Your Comment on The Point Solar Farm (Far North Solar Farms)

- 1.1 Transpower New Zealand Limited (Transpower) has been invited to comment on The Point Solar Farm Project (the Project) under section 53(2)(i) of the Fast-track Approvals Act 2024 (FTAA) as the owner of adjacent land. Transpower is also the occupier of the land to which the Substantive Application relates (section 53(2)(h)). Thank you for the opportunity to provide comments.

- 2.1 The Project proposes to construct and operate a solar farm across approximately 670 hectares and connect and supply electricity to the National Grid via a new Grid Injection Point (GIP) substation. Transpower would construct and operate the Transpower portion of the substation and maintain a long-term presence at the site.

Appendix A – Transpower Asset Map

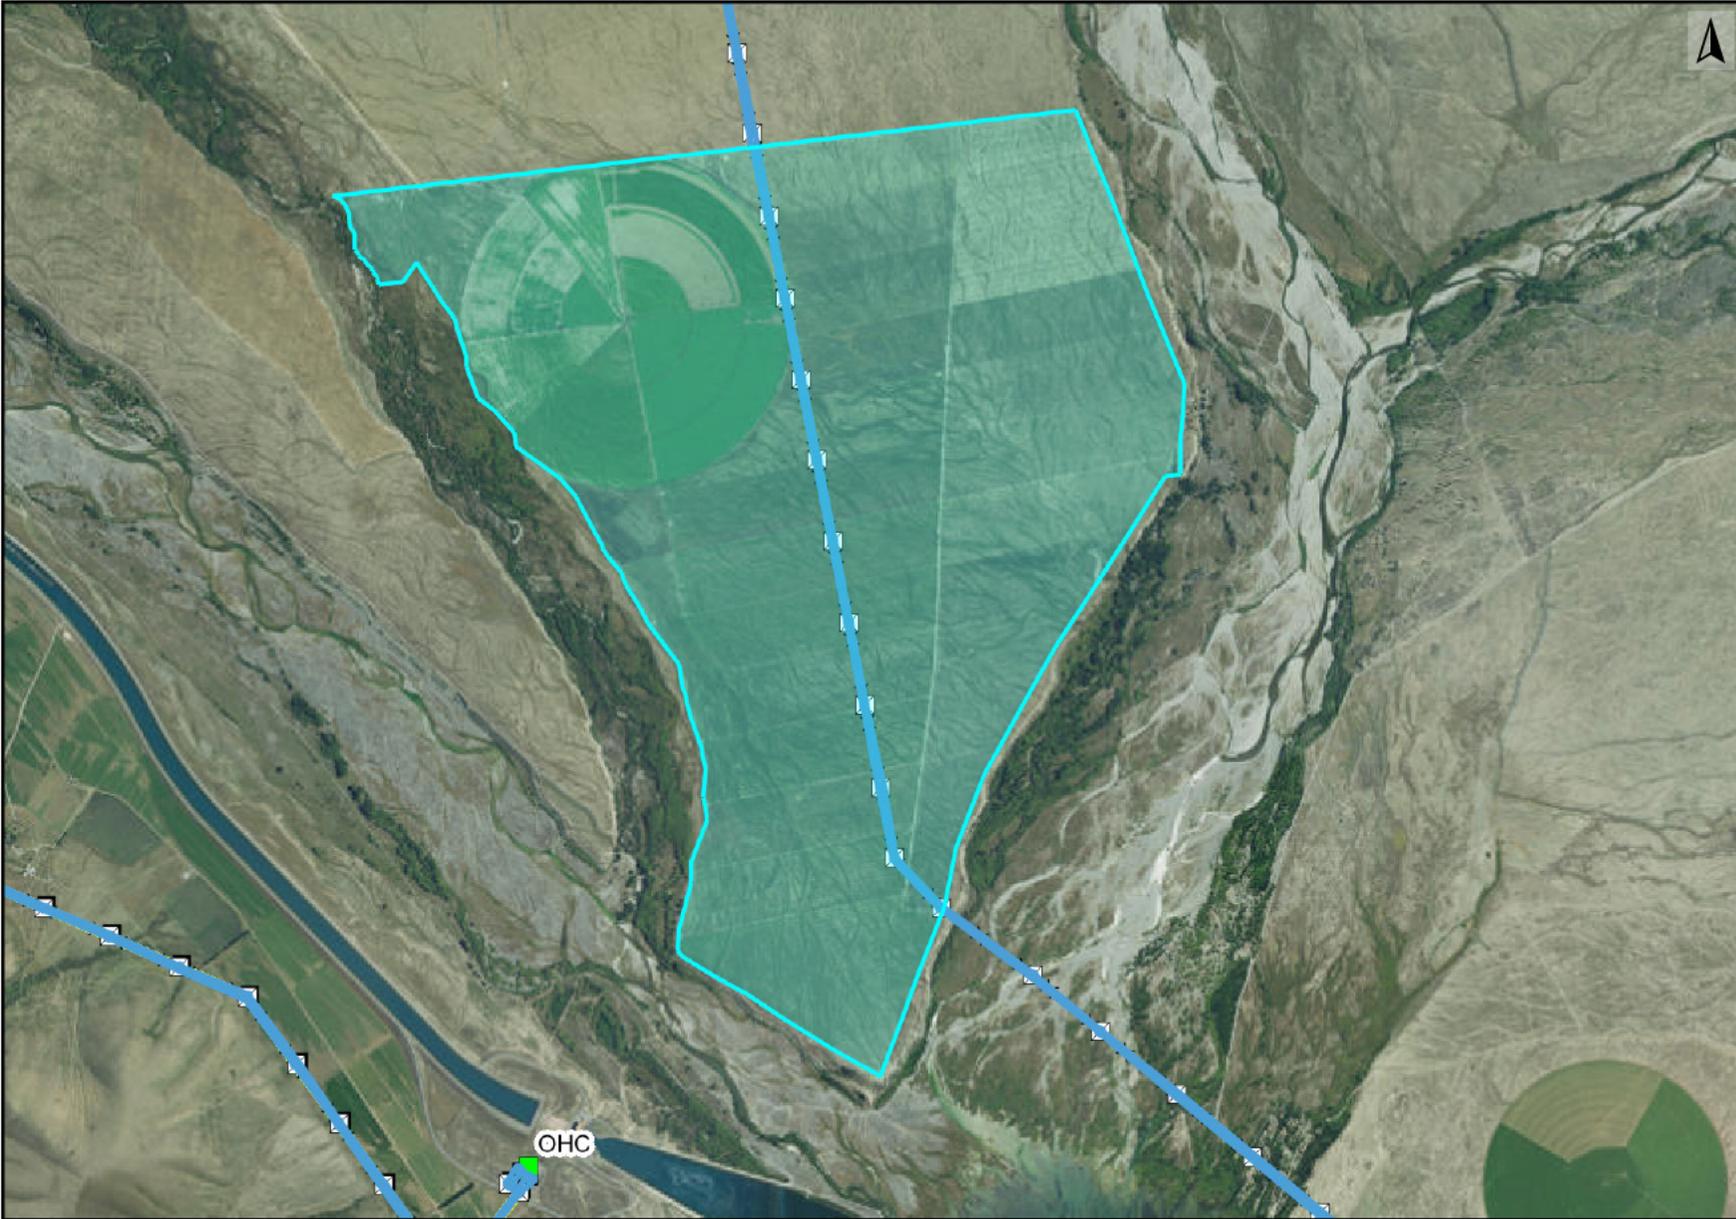
- 2.2 As shown on Transpower's 'Asset Map' in Appendix A, the Benmore to Islington A 220 kV transmission line (BEN-ISL-A line) traverses the Project site. The line is not designated, and Transpower relies on Policy 11 and 12 of the National Policy Statement for Electricity Networks 2008 (NPS-EN) to protect the line.

- 4.2 The BEN-ISL-A National Grid transmission line traverses directly through the centre of the site in a north to south direction, with this portion of the site subject to the NGY. This line is supported by multiple support structures (BEN-ISL-A0079 - BEN-ISL-A0088).
